HISTORIC AND DESIGN REVIEW COMMISSION

February 15, 2023

HDRC CASE NO: 2023-039
ADDRESS: 918 N PINE ST
LEGAL DESCRIPTION: NCB 1653 BLK A LOT 4 AT 918 PINE N
ZONING: R-5 CD, H
CITY COUNCIL DIST.: 2
DISTRICT: Dignowity Hill Historic District
APPLICANT: David Ericsson
OWNER: David Ericsson
TYPE OF WORK: Construction of a metal carport, CMU wall construction, and landscaping
APPLICATION RECEIVED: January 27, 2023
60-DAY REVIEW: Not applicable due to City Council Emergency Orders
CASE MANAGER: Edward Hall

1 PLAN 918 N PINE CARPORT
SCALE : 1/8" = 1'-0"

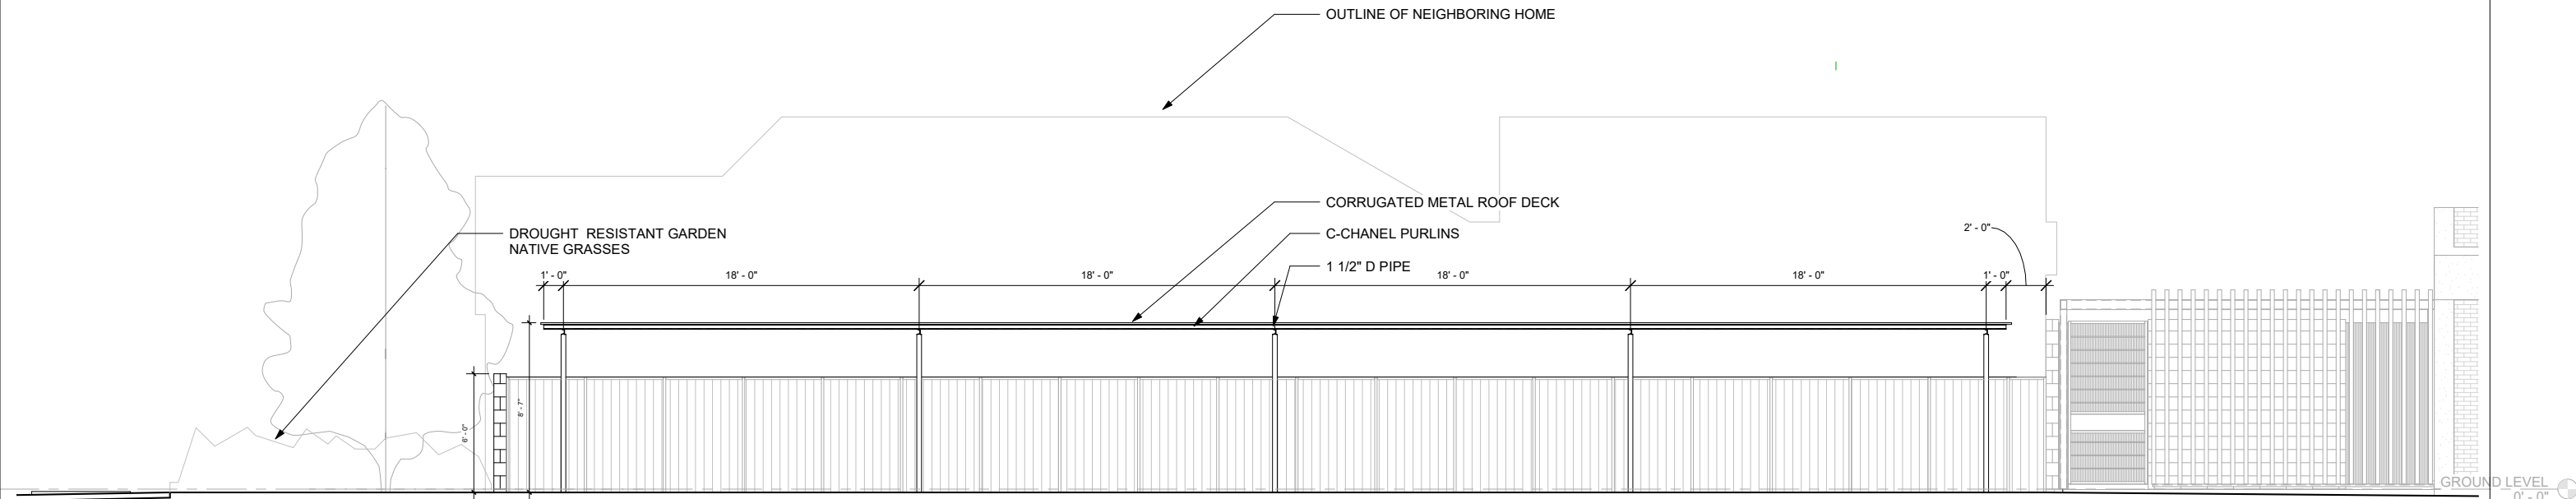
- c. CARPORT (Masing & Form) – The applicant has proposed to construct a steel carport structure to feature an overall length of 74' – 0", an overall depth of approximately 20' – 0", and an overall height of 8' – 7". The proposed carport will be located in a position that would occupy space formerly occupied by a historic structure. The Guidelines for New Construction 5. Notes that new garages and outbuildings should be designed to be visually subordinate to the primary historic structure on the lot, should be no larger in plan than 40 percent of the primary historic structure's footprint, should relate to the period of construction of the primary historic building on the lot, should be located consistently with the predominant garage and outbuilding orientation on the lot, and should follow the historic setback pattern of the block. Staff finds the location and materials of the proposed carport to be inconsistent with the Guidelines. Covered parking with an increased setback featuring traditional building materials such as wood framing would be more appropriate within the Dignowity Hill Historic District.

- d. CMU WALL – The applicant has proposed to construct a CMU wall parallel to N Pine Street to screen the proposed parking from view from the right of way. The applicant has proposed for the wall to feature six (6) feet in height. The Guidelines for Site Elements 2.B.i. notes that new fences and walls should appear similar to those used historically within the district regarding transparency, scale and character, should be located where historically found, should be limited to four (4) feet in height, and should feature traditional fencing materials. Exposed CMU are prohibited by the Guidelines as a fencing and wall material.

1. Staff does not recommend approval of item #1, the construction of a steel carport structure based on finding c. Staff recommends the applicant proposed a carport with a location and materials consistent with the Guidelines for New Construction.
2. Staff does not recommend approval of item #2, the construction of an exposed, CMU wall parallel to the front property line and right of way, based on finding d. Staff recommends the applicant proposed fencing that is consistent with the Guidelines and historic examples found within the district.
3. Staff recommends approval of item #3, the installation of a landscape garden to feature native grasses based on finding e with the stipulation that a detailed landscaping plan be submitted for review and approval that should be consistent with the Guidelines and adopted policy documents.
